Product Change Description

Model Name: L15A2,L15B2
HW: Main Board:6490Coreboard_MB_V3.0
IO Board: T3 Pro_SUB_V3.0
SW: 3.0.0
FCC ID: 2AH25T3PRO
IC: 22621-T3PRO

is the variant of the initial certified product,

Model Name: L15A1,L15B1
HW: 6490Coreboard_MB_V2.0
IO Board: T3 Pro_SUB_V2.0
SW: 1.0.0
FCC ID: 2AH25T3PRO
IC: 22621-T3PRO

Model Name: L15A1,L15B1(Initial)	Model Name: L15A2,L15B2
----------------------------------	-------------------------

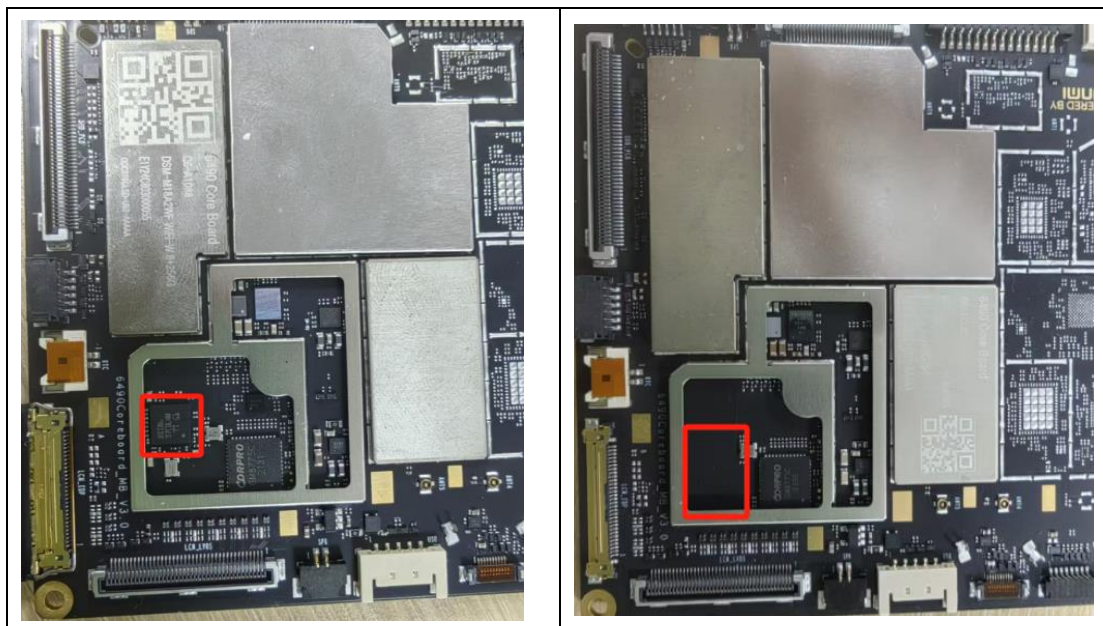
Band changes: NO
Power Amplifier changes: NO
Antenna changes: NO
PCB Layout changes: NO
Components on PCB changes:
1)Main Board>Delete MIPI to eDP IC U5201 and its peripheral devices.
